FARMS & RANCH EQUIPMENT

NEW 70' X 120'
SHELTER ADDTION

SITE PLAN & ACCESS

DRAWING NO.: AXE-26-3674-ARC-PLN-001

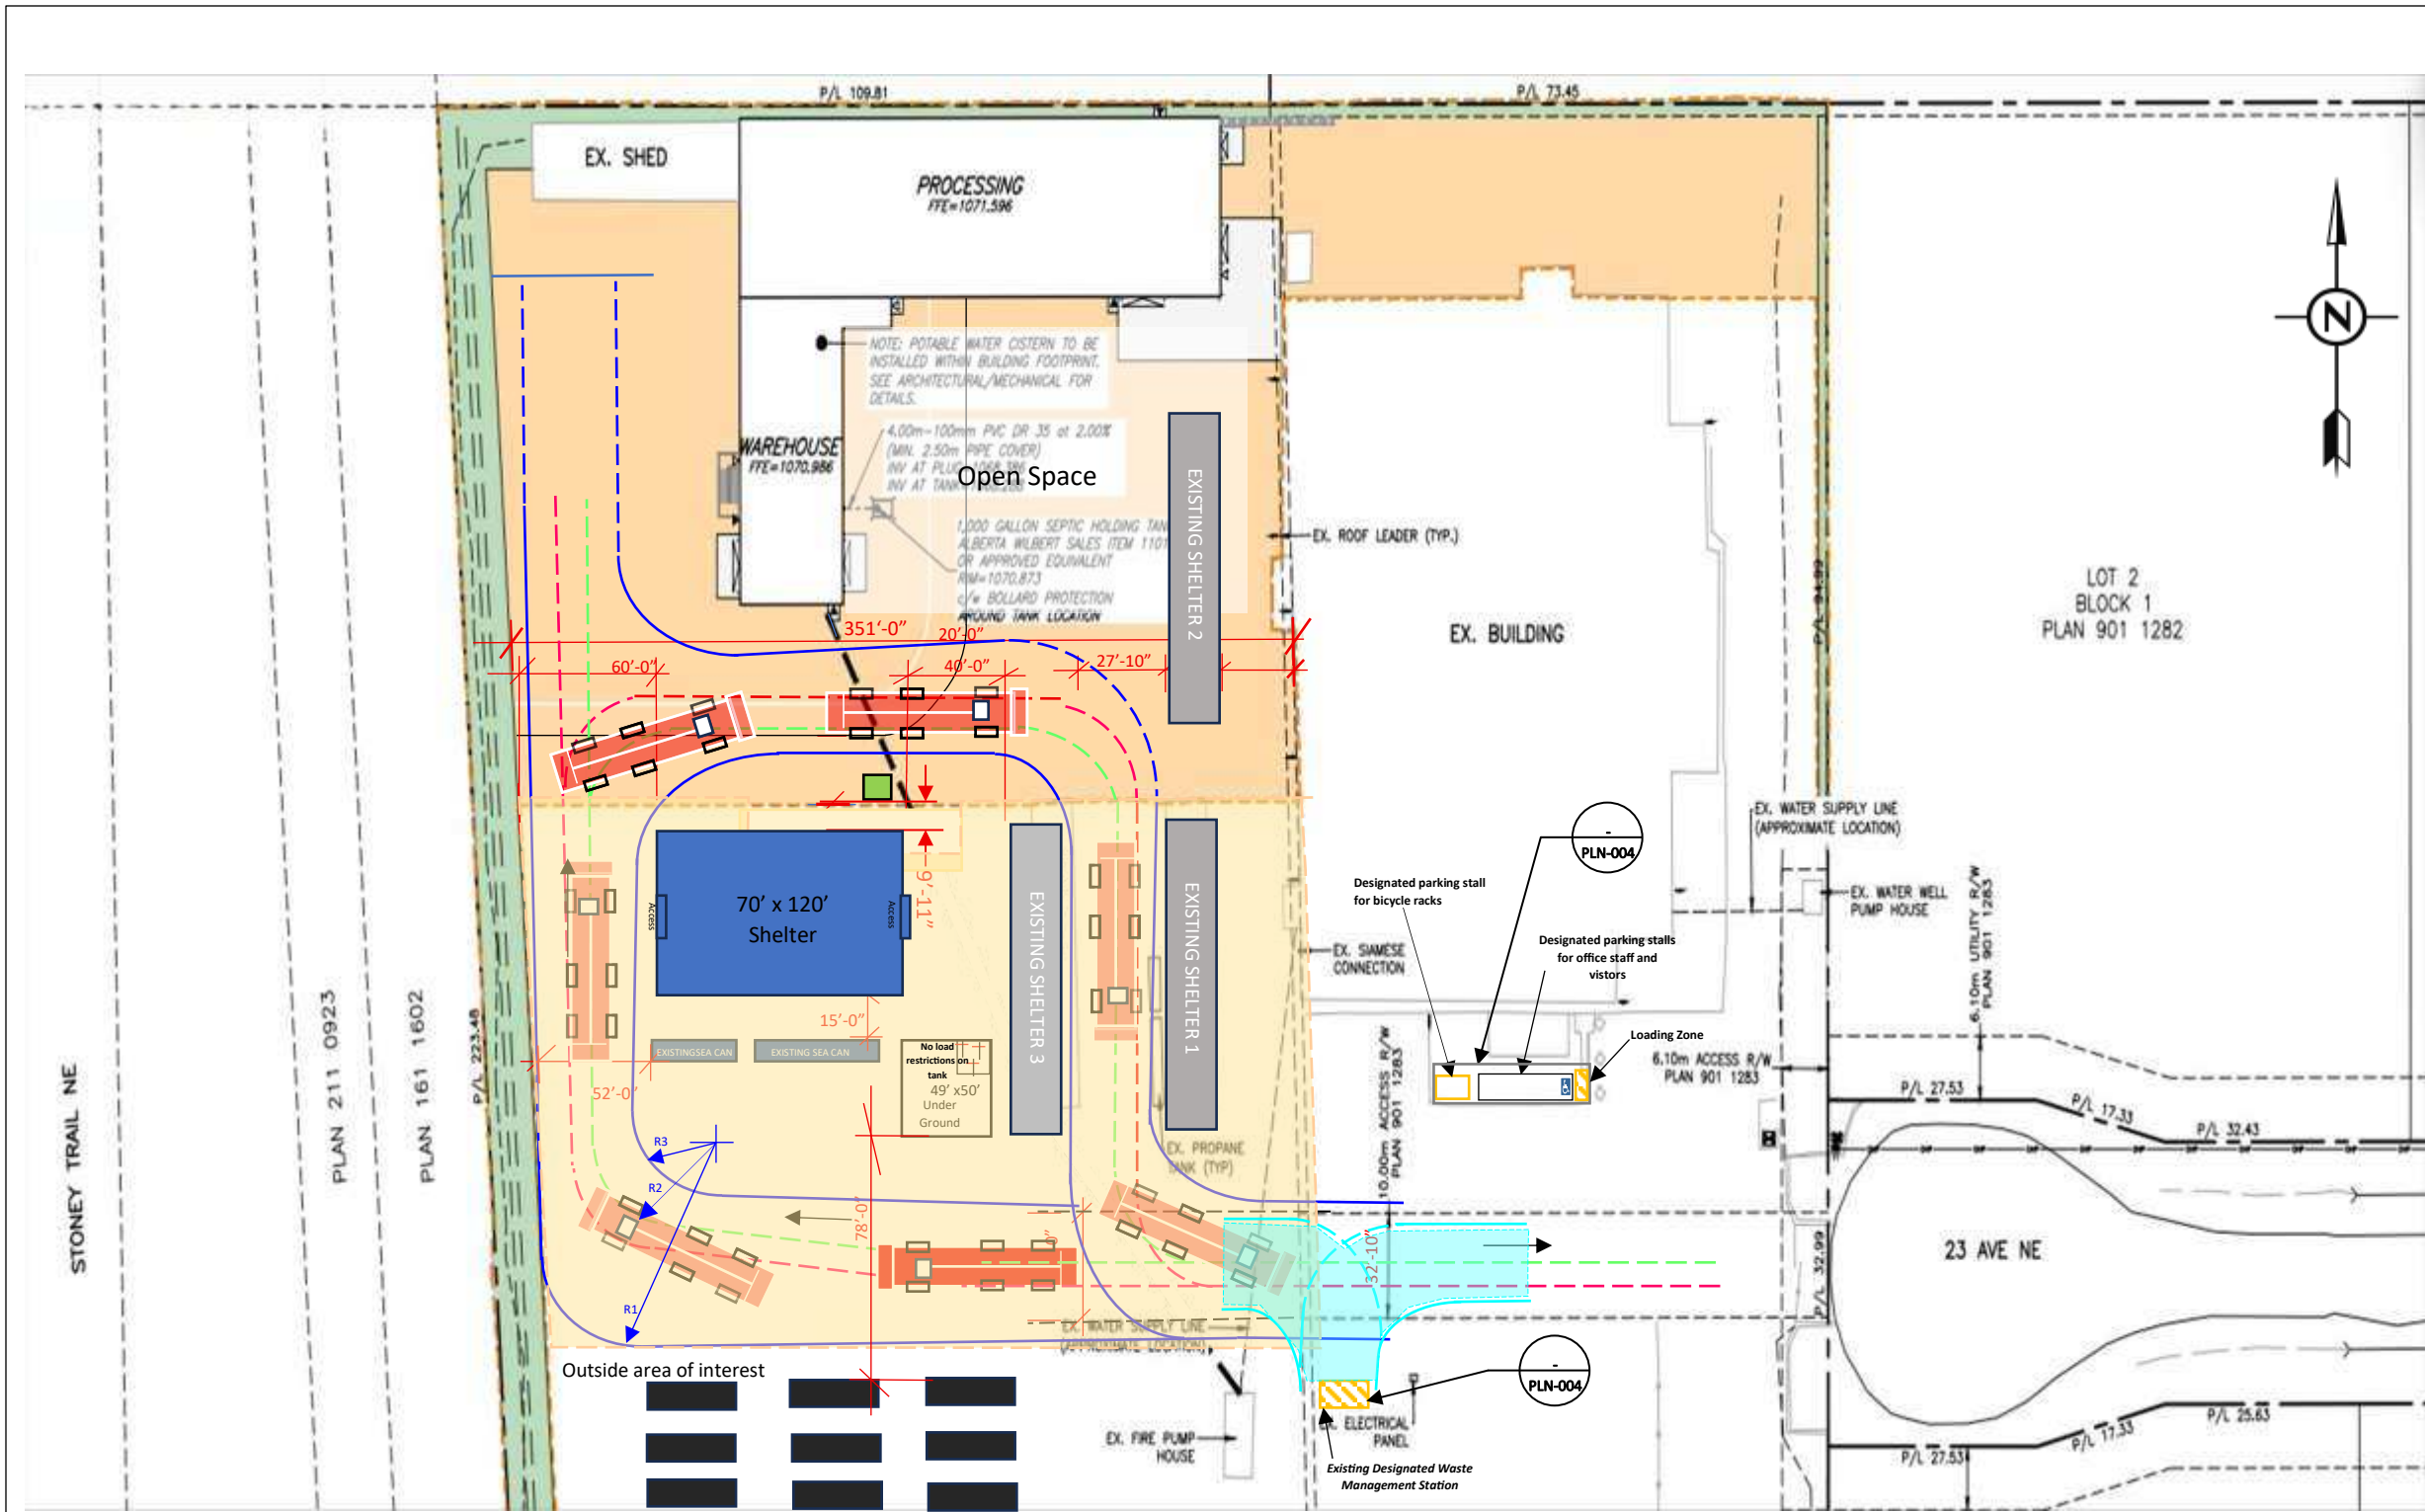
- a) Updating missing structures on Rev. B.
- b) Updating FD access route.
- c) Indicate the waste management station.
- d) Indicate the bicycle racks parking stall.
- e) Adding minimum Enmax clearances requirements (i.e., Transformer, etc.).
- f) Updating general notes section.
